From: Waters, David [David.Waters@pgnmail.com]
Sent: Monday, July 02, 2012 5:12 PM
To: Habib, Donald
Cc: Keenan, Christopher; Kitchen, Robert; Wilkins, Tillie; Franklin, Mike; ANAND.K.SINGH@sargentlundy.com
Subject: Clarification to Option A CEUS SSC Hazards Evaluation for LNP Site
Attachments: CEUS SSC Evaluation Process - Option A 07 02 12.pdf

OPTION A: EVALUATION OF CEUS SSC SEISMIC HAZARDS AT LNP SITE

Response for RAI L-0998

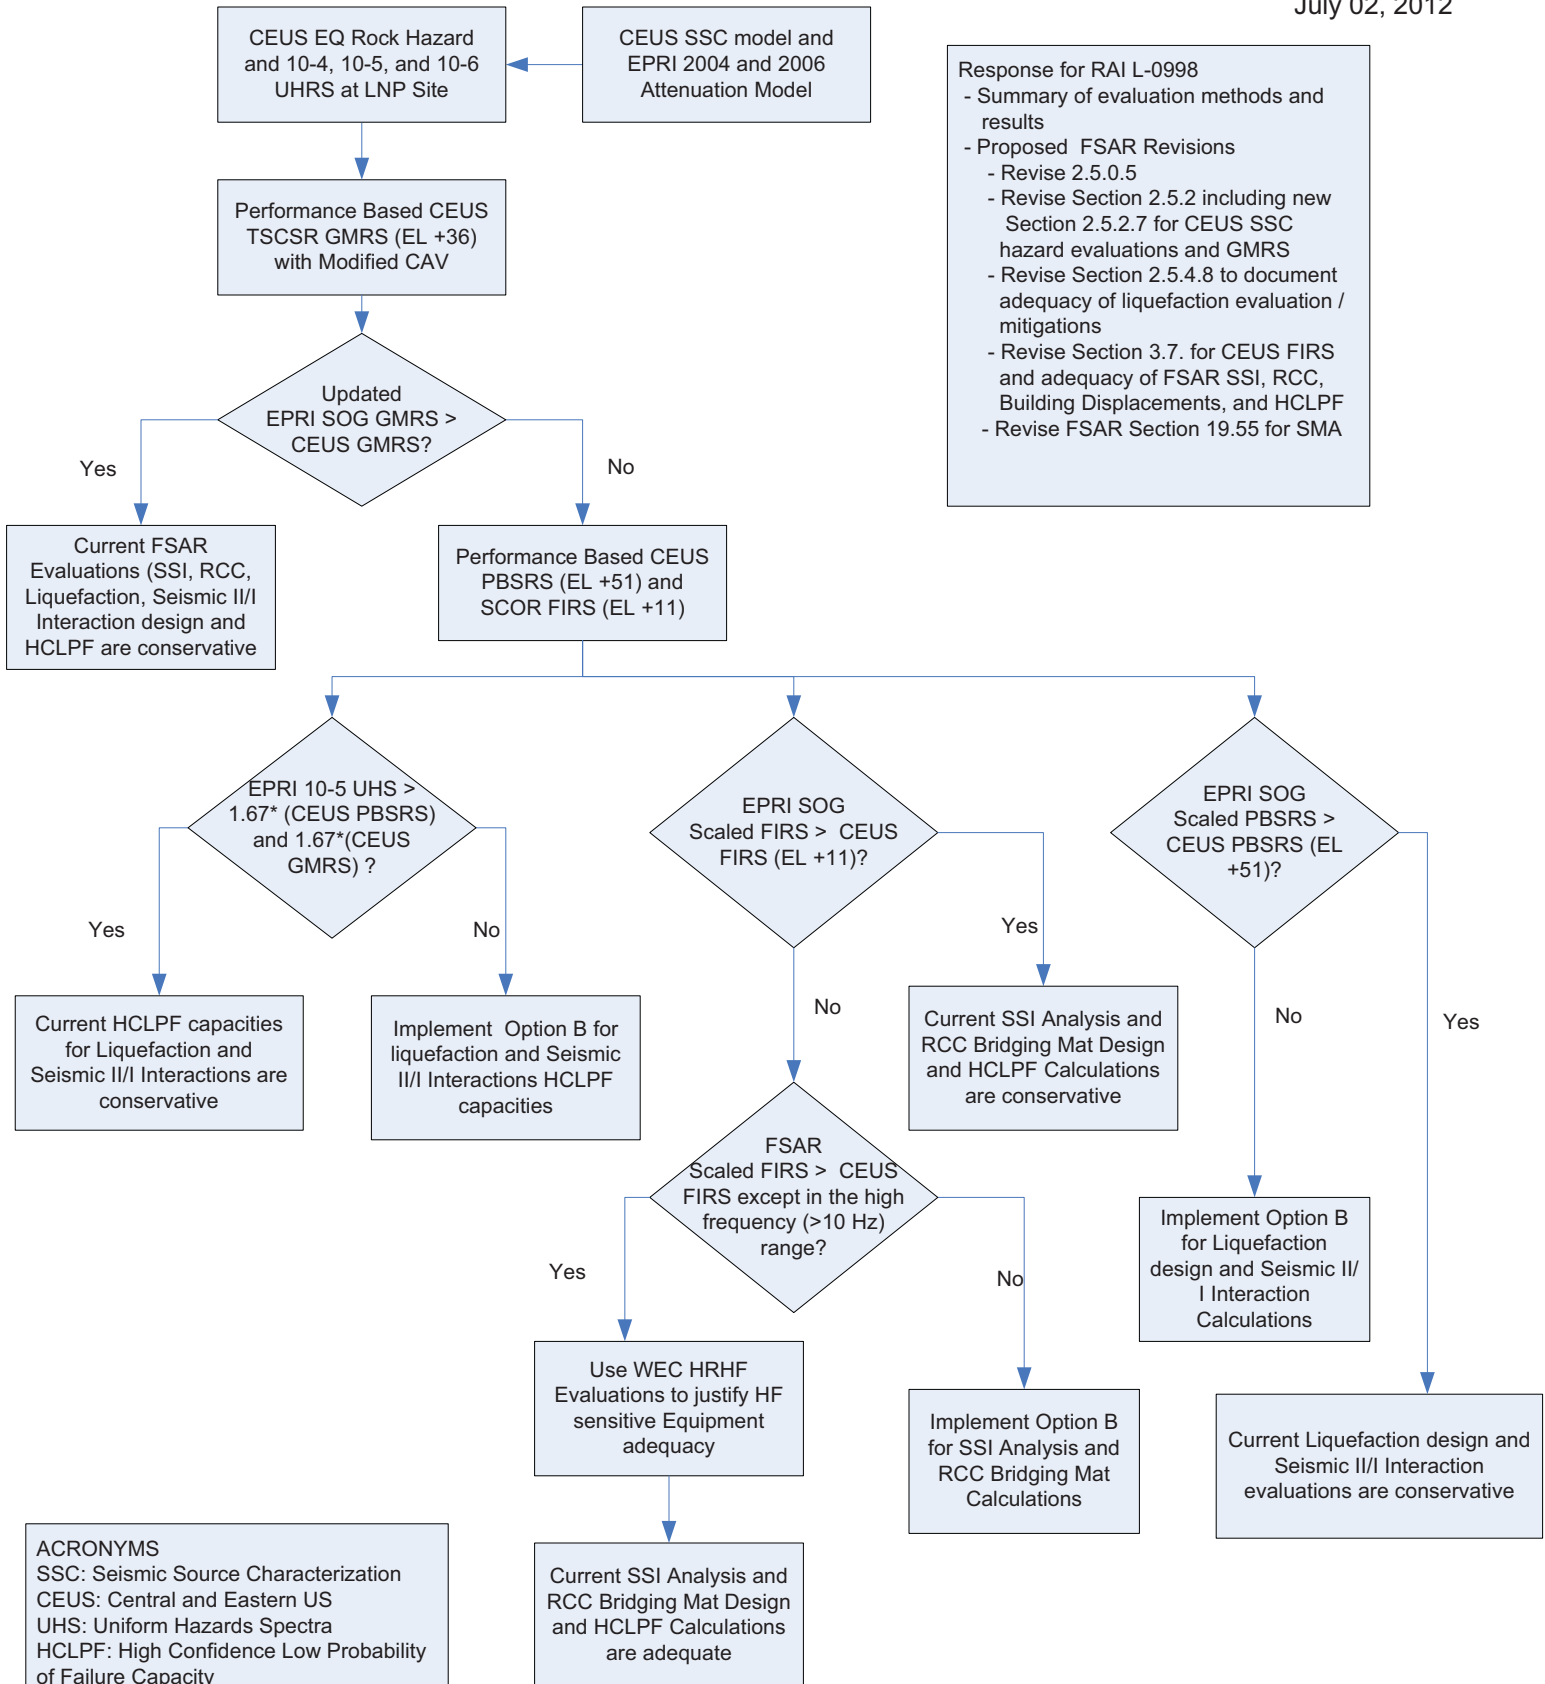
AK Singh has clarified the Option A flowchart to address the concern identified by the structural reviewers as discussed last Thursday. We are sending you this revised chart for use in the public meeting on Thursday, if necessary.

- Summary of evaluation methods and results
- Proposed FSAR Revisions
 - Revise 2.5.0.5
 - Revise Section 2.5.2 including new Section 2.5.2.7 for CEUS SSC hazard evaluations and GMRS
 - Revise Section 2.5.4.8 to document adequacy of liquefaction evaluation / mitigations
 - Revise Section 3.7. for CEUS FIRS and adequacy of FSAR SSI, RCC, Building Displacements, and HCLPF
 - Revise FSAR Section 19.55 for SMA
